St Margarets Chambers
For Charlotte Street Estates

Lightwell Elevations - Proposed Repairs and Conditions 2/2

scheme 1907
drwg no. **P(237)**
revision

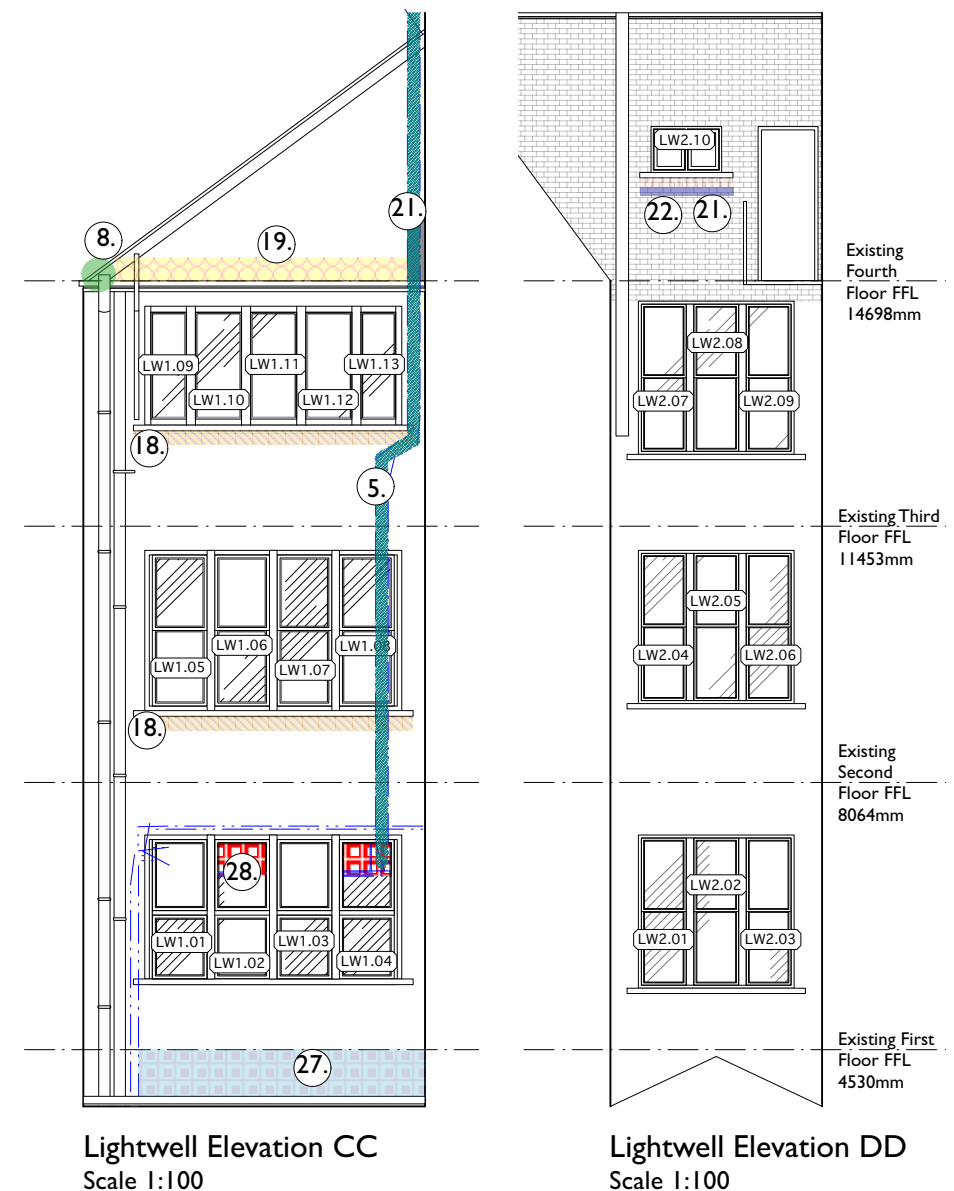
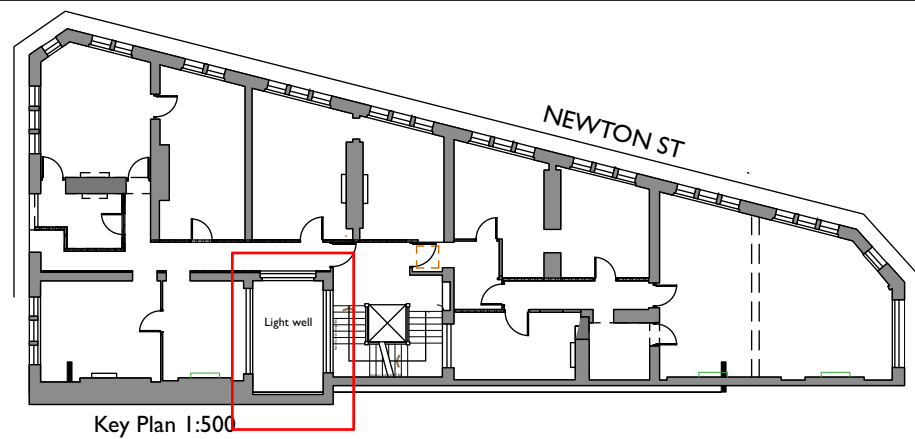
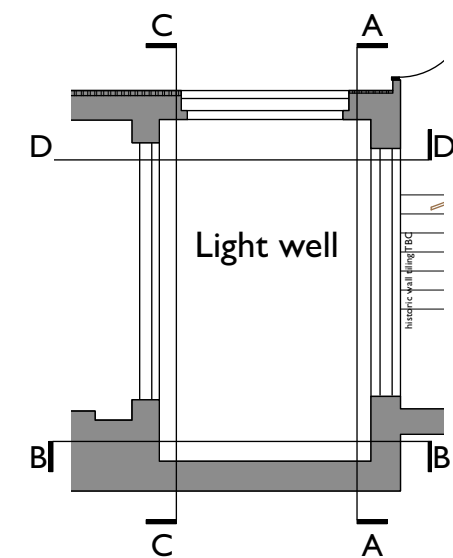
- 1 Sandstone erosion - close inspection required.
- 2 Holes left by redundant fixings - mortar fill in accordance with specification.
- 3 Gaps in brickwork. Close inspection required to inform replacement with matching material.

- 4 Missing pointing between frieze panels. Reinstall in accordance with specification.
- 5 Redundant plant equipment carefully remove and make good fabric in accordance with specification.

- 6 Eroded sandstone coping. Close inspection required. Replacement matching stone inserts may be required to prevent further deterioration.
- 7 Rusting lintels Clean off and repaint in accordance with specification.

- 8 Biological growth to be removed from roof level.
- 9 Coping water staining. May require repointing. Close inspection required.
- 10 Previous repairs to sandstone. Poorly matched aesthetic and presumed composition, but no evidence repairs are causing damage to surrounding historic fabric. Add to building maintenance plan for regular monitoring.

- 11 Biological growth to stone to be cleaned in accordance with specification.
- 12 Water staining may be caused by missing pointing. Close inspection required to inform repair strategy.

- 13 Signs of cracking. Further inspection required on site.
- 14 Redundant cables/lights/alarm box. Carefully remove
- 15 Residue from former sign to be cleaned off sandstone. Method pending site trials.

- 16 Existing timber to be carefully removed from brickwork

- 17 Clean off atmospheric dirt from glazed tiles
- 18 Redecorate cill
- 19 Clean-out gutters
- 20 Missing slate to be investigated once high level access provided
- 21 Repair and redecorate timber window frame and rotten cill
- 22 Clean concrete cill
- 23 Reinstall missing pointing
- 24 Inspect felt roof
- 25 Loose board and flashing to be repaired
- 26 inspect stone cill. Possible damage causing biological growth and staining to wall
- 27 Paint flanking and signs of damp further inspection required
- 28 Reinstall original sash configuration

Allow for the renewal of gutters and rainwater outlet to roof
